Access Compliance Report

Public Rights-of-Way

(Pedestrian Signals)

Intersection ID: N/A	Main Street:	Cross Street: N/A	Location: N/A
ADA ID: FC9845C84941	Signal Type: One Push Button-APS	Overall Compliance: No	Severity Score: BTN 1: N/A BTN 2: N/A No BTN: N/A
Codes/Mitigation Info/Possible Solution		Field Measurements/Component Compliance

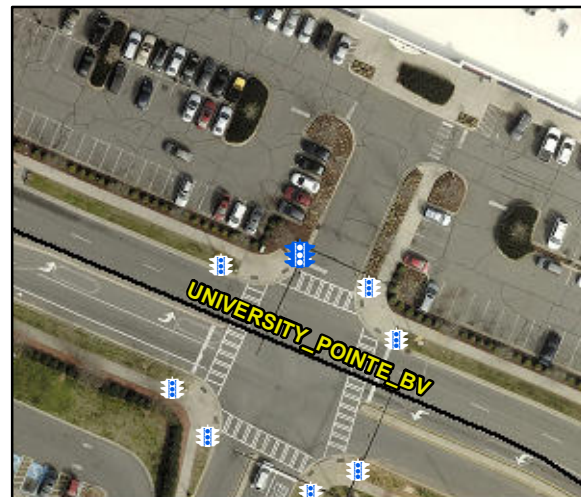
N/A	B 1 FWD Approach Width (in)	N/A	N/A	B 2 FWD Approach Width (in)	N/A
N/A	B 1 FWD Approach Obstruction?	Yes	N/A	B 2 FWD Approach Obstruction?	N/A
N/A	B 1 FWD Approach Obstruction Dist (in)	4.0	N/A	B 2 FWD Approach ObstructionDist (in)	N/A
N/A	B 1 PARA Approach?	Yes	N/A	B 2 PARA Approach?	N/A
N/A	B 1 PARA Approach Constrained?	Yes	N/A	B 2 PARA Approach Constrained?	N/A
No	B 1 PARA Approach Reach (in)	14.0	N/A	B 2 PARA Approach Reach (in)	N/A
No	B 1 PARA Approach Width (in)	48.0	N/A	B 2 PARA Approach Width (in)	N/A
N/A	B 1 PARA Approach Obstruction?	Yes	N/A	B 2 PARA Approach Obstruction?	N/A
N/A	B 1 PARA Approach Obstruction Dist (in)	4.0	N/A	B 2 PARA Approach ObstructionDist (in)	N/A
No	B 1 Clear Floor Space Slope (%)	7.0	N/A	B 2 Clear Floor Space Slope (%)	N/A
Yes	B 1 Clear Floor Space XSlope (%)	0.7	N/A	B 2 Clear Floor Space XSlope (%)	N/A
N/A	B 1 PAR Slope (%)	N/A	N/A	B 2 PAR Slope (%)	N/A
Yes	B 1 Height (in)	35.0	N/A	B 2 Height (in)	N/A

Possible Solutions: Remove & Replace
Replace APS Button With New APS Button.
Remove and Replace Clear Space.
